Service Bulletin

ALL SIDE-BY-SIDE REFRIGERATORS
WITH ICE DISPENSER IN DOOR

REF 01-07

REPLACEMENT OF AUGER MOTOR

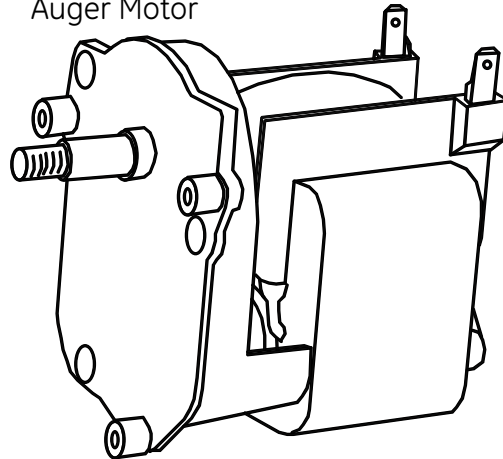
There is some difference in terminal spacing width from previous auger motors. The boot that covers the auger motor is flexible, so the same boot can still be used by fitting the terminals through the holes in the boot.

When replacing motors with older style gearbox, it is possible only 2 of the 3 mounting holes will align. In these cases, omit the third screw.
